Post plane Theater Plaza Bldg

Memorandum from Department of Building Inspection, Portland, Maine  
Greenwood Garden, Peaks Island—Concrete piers for foundation of theatre building  
owned by Mrs. A. W. Jensen, Builder, Henry S. Hoar—5/19/42  
To Owner and Builder:

Statement of Minimum Requirements Relating to the Greenwood Playhouse at Peaks Island to Receive the Approval of the Inspection Board of the City of Portland for a Theatre License for 1941 (the License of course Being Issued by the Municipal Officers)

SPECIFICATION ACCOMPANYING APPLICATION FOR BUILDING PERMIT RELATING TO ALTERATIONS  
IN THE THEATRE IN GREENWOOD GARDENS, PEAKS ISLAND

Post Plan for Theater

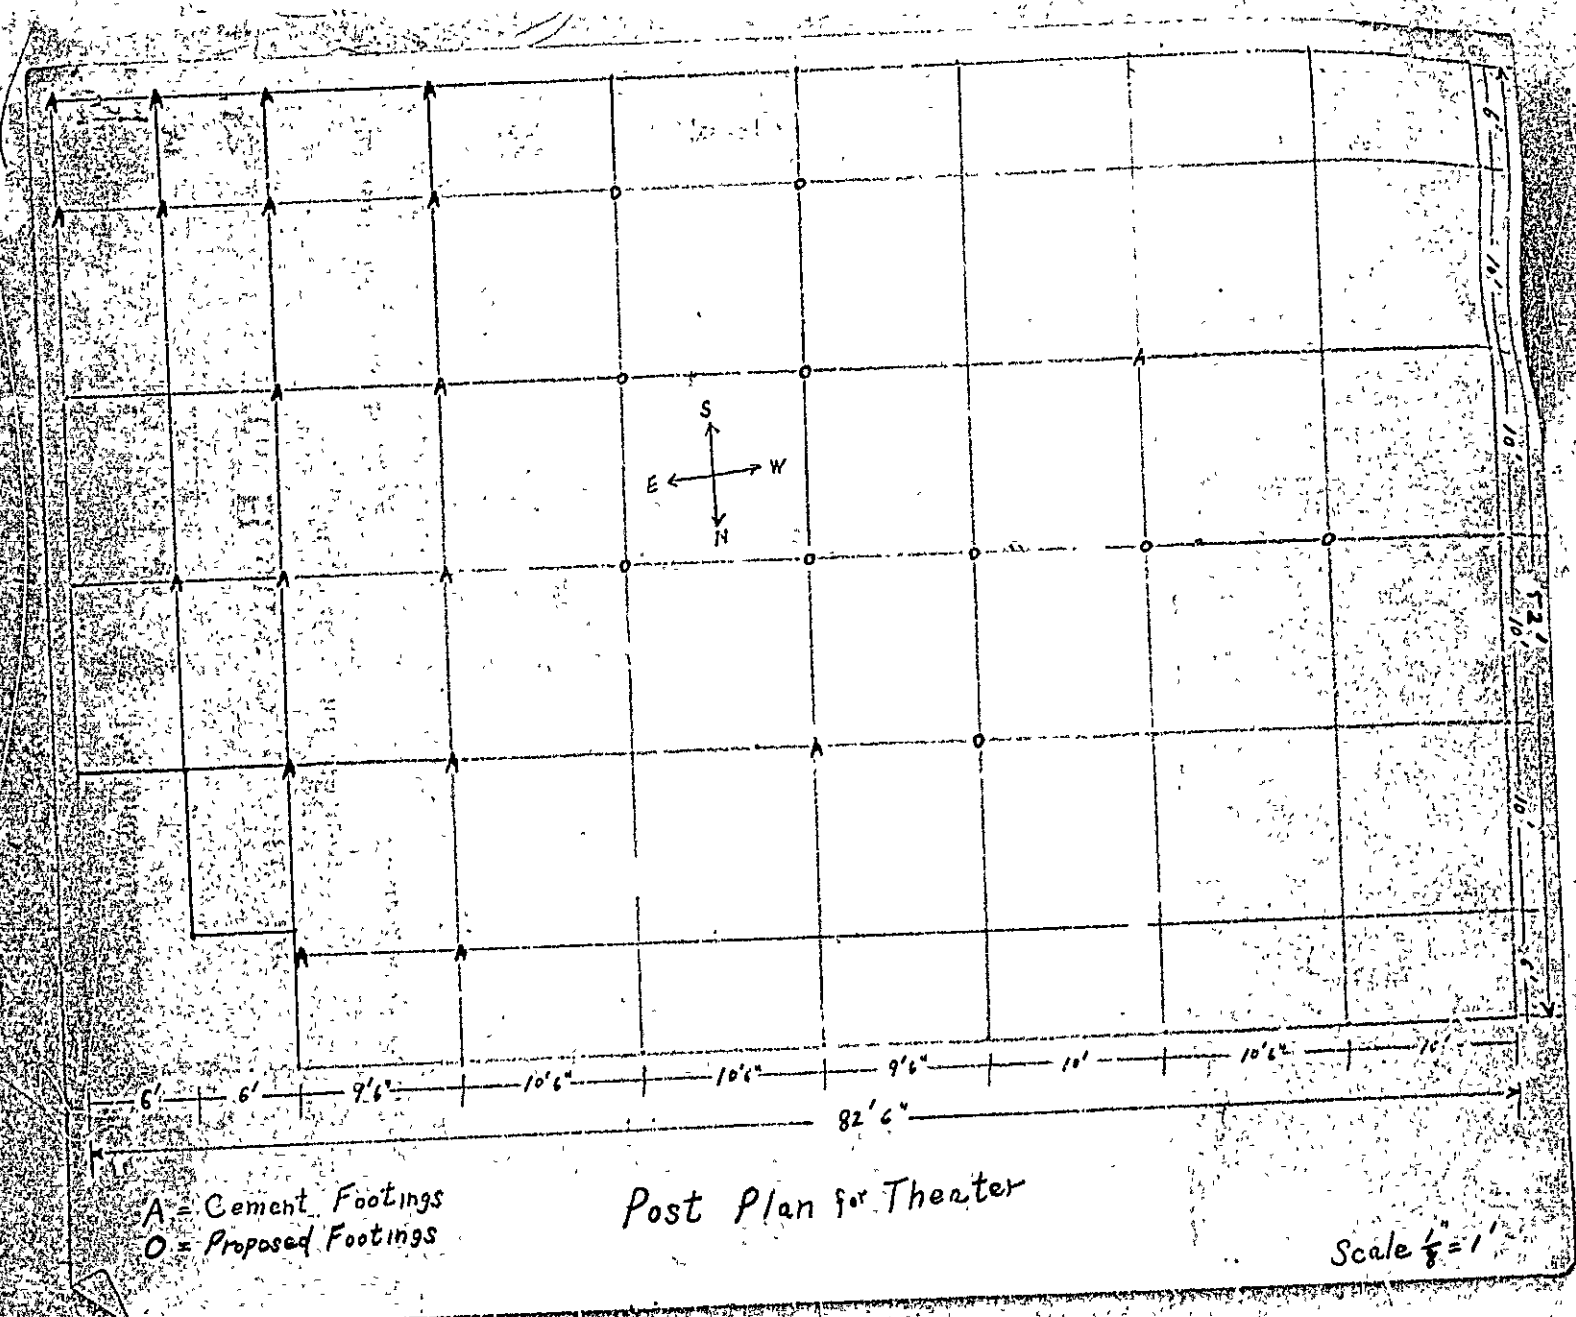
The application and sketch show the location of footings now built and those proposed to be built this year, but no details of the piers themselves.

That there may be no misunderstanding, let me repeat the understanding reached about the details of these piers among many other matters in February, 1941. This statement later agreed to by all concerned, read as to piers as follows: "These footings should be large enough at the top to accommodate the full bearing of the wooden post, should batter outwards on four sides at least an inch on each side in the depth of the footing, should extend four feet below the grade of the ground or to a flat bearing on ledge (natural or prepared) whichever is encountered first, should extend at least six inches above the top of the ground or rock, and each post should be anchored to its footing, preferably by a metal dowel inserted in the bottom of the post and cast into the concrete."

This permit is issued on the basis of the above understanding.

Pro Stage Extension  
and Outside Platform

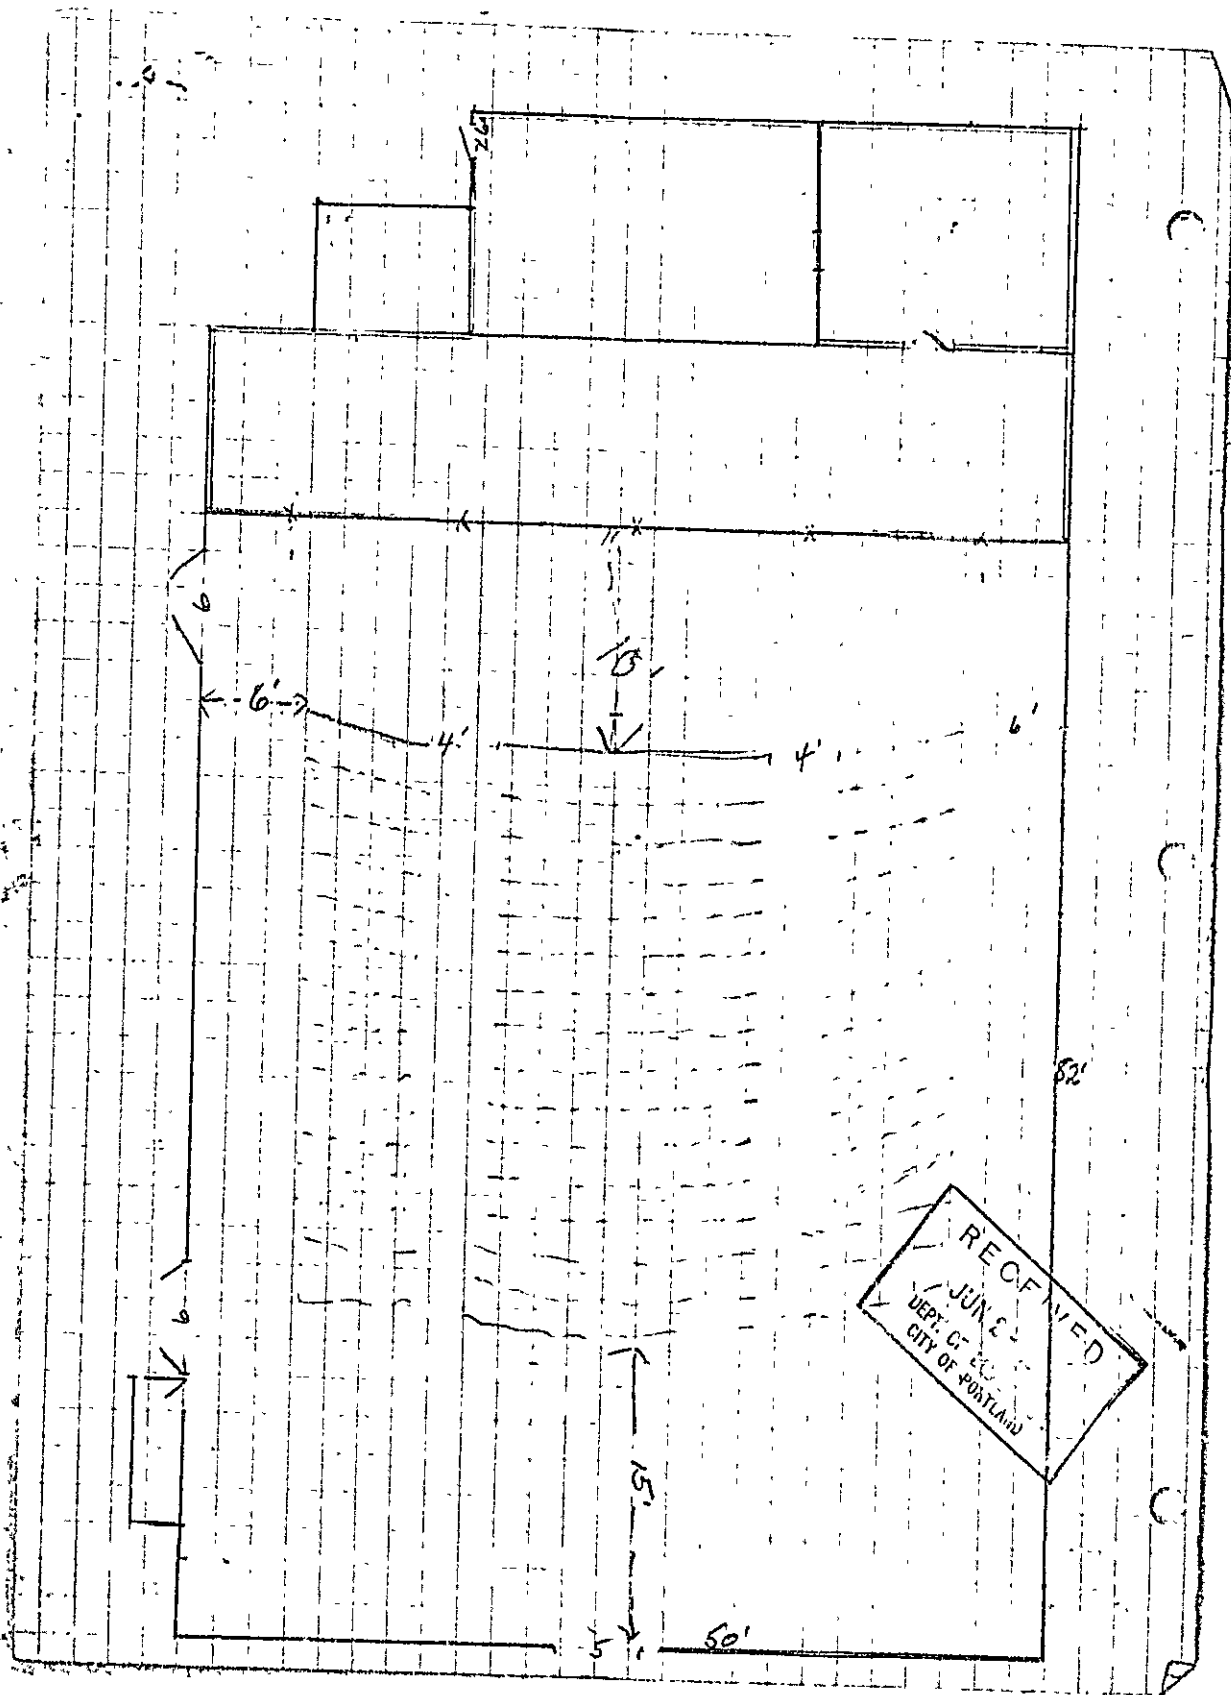
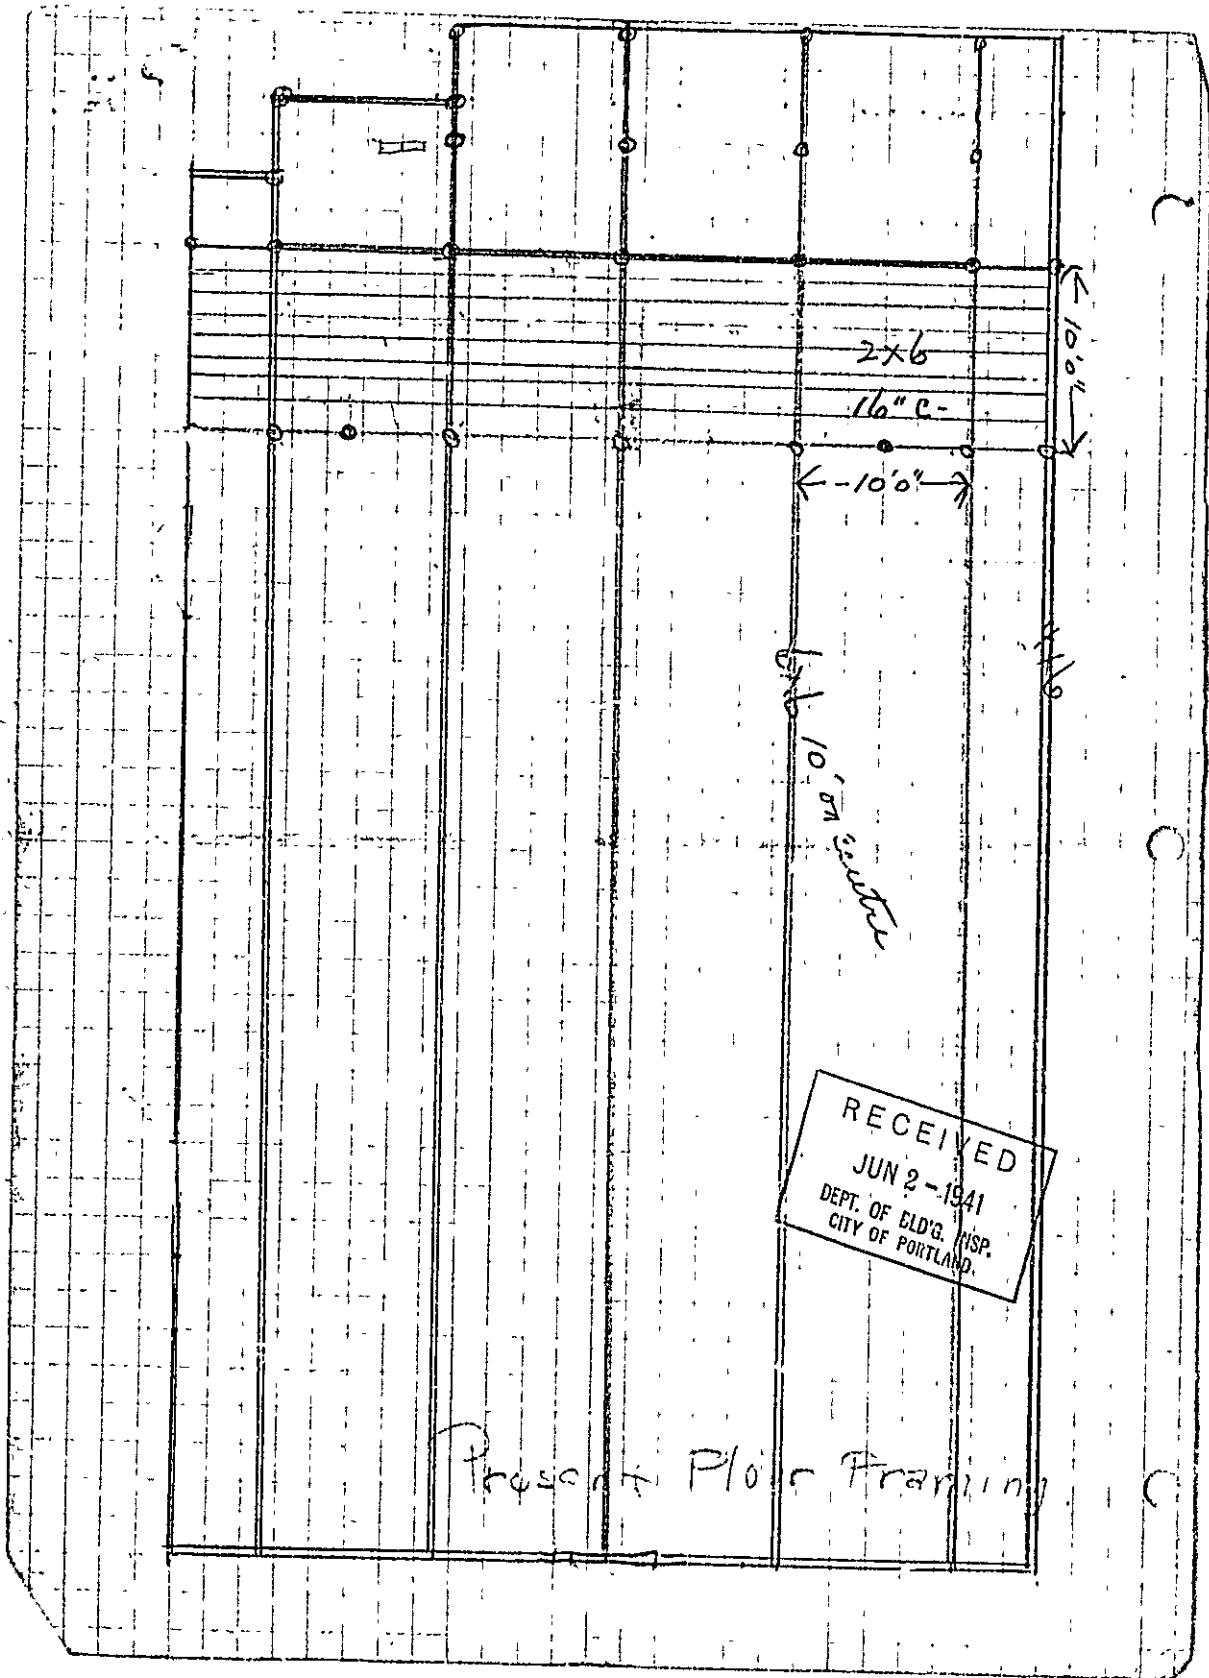
To construct an extension of the stage 10' deep and the width of the building, about 50', to be framed as indicated on sketch attached - all material used in the framing of the stage to be dressed on all sides.  
 To remove the existing ramp on the end of the building, and to construct in its place an outside platform 6' x 8' with two steps to the ground level, to be framed as indicated on sketch attached.  
 To remove the dilapidated open platform on the harbor side of the building and permanently close all doors leading to this platform.  
 To provide concrete piers under the existing posts which would be beneath and act as supports of the stage extension, and to provide similar piers beneath all existing posts that have rotted or become questionable, all of these piers to adequately support the posts and to extend to ledge rock or four feet below the surface of the ground whichever is encountered first.

4. The extension of the stage will be framed and braced to support a theoretical load of at least 100 pounds per square foot. Because it is undesirable to fasten this extension to the floor of the building, all uprights will have a square, flat bearing on the floor and will be braced horizontally at the floor level and diagonally from the bottoms of the uprights.

TOILETS AS BUILT  
ANTON JENSEN  
PERKS ISLAND  
35/1568

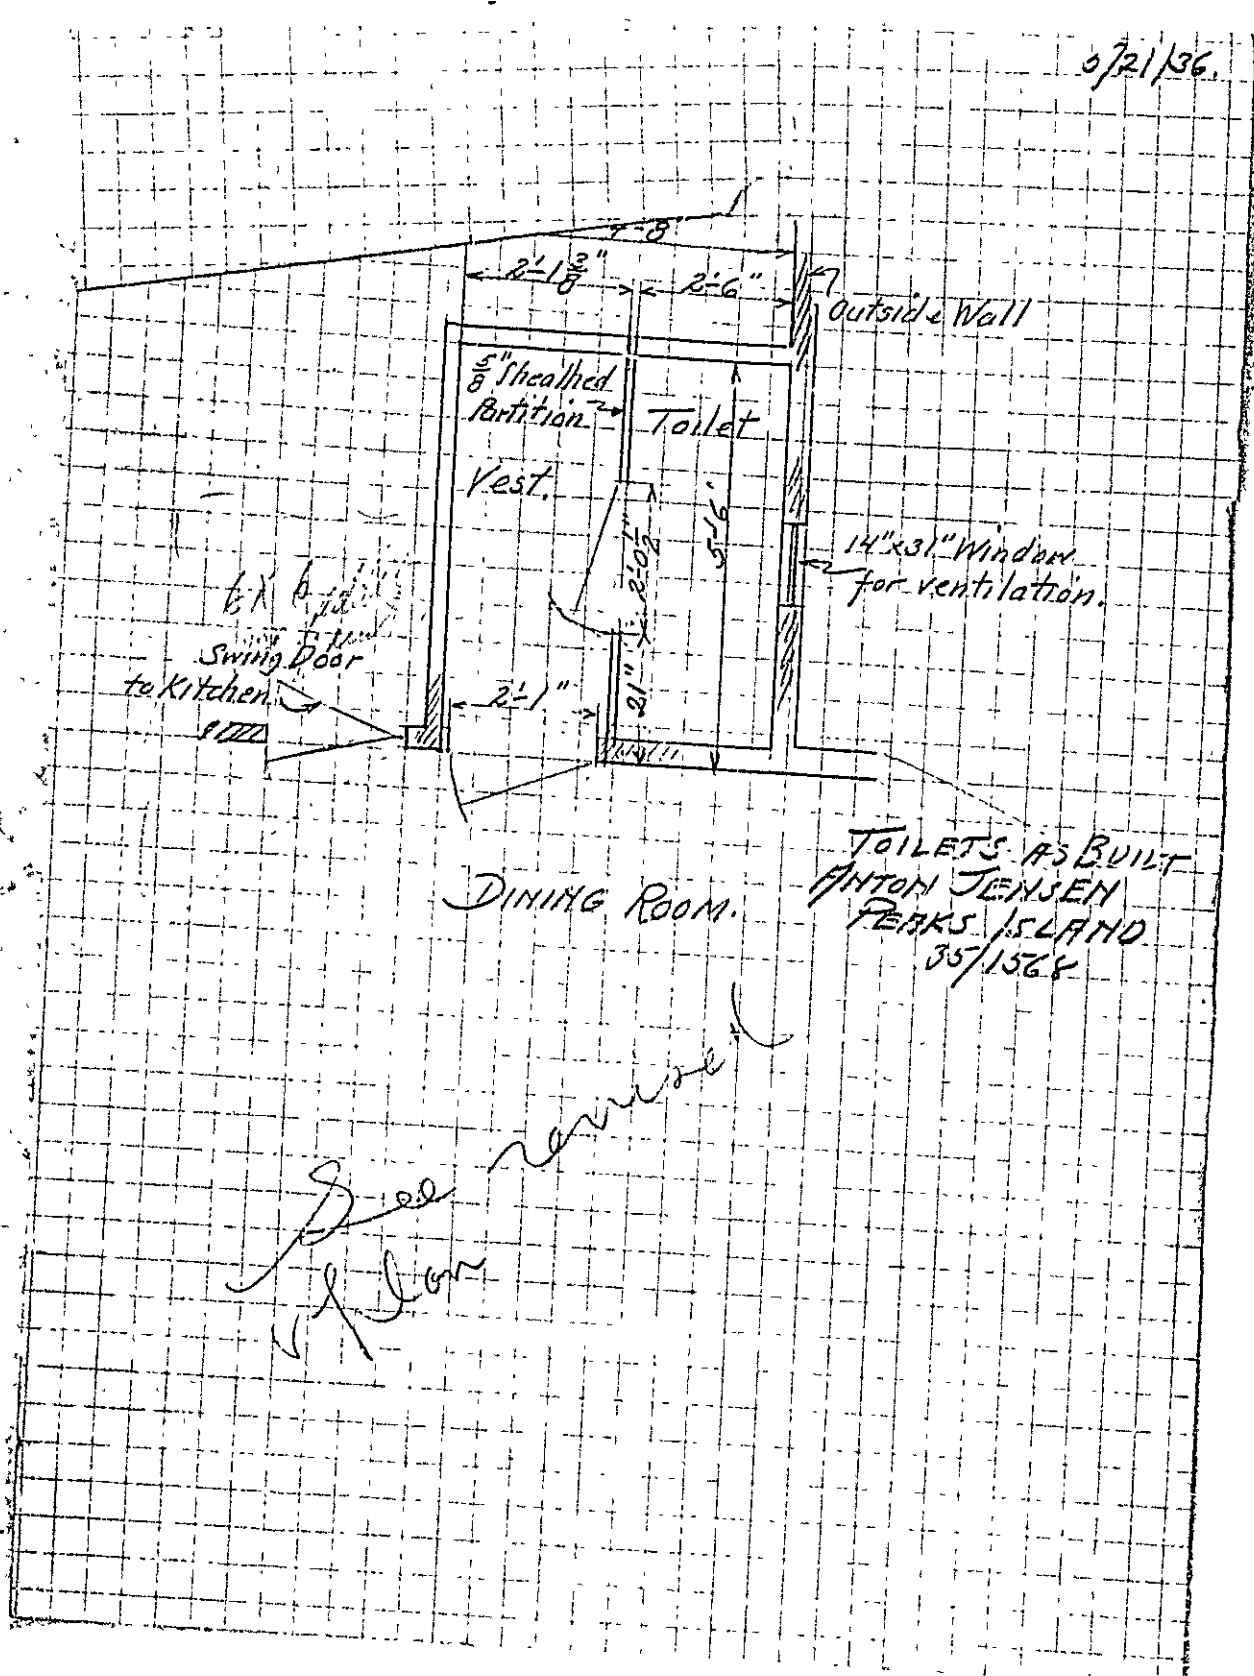
See revised  
plan

To locate toilets and vestibules as shown on plan filed with this amendment, and not as on original plan
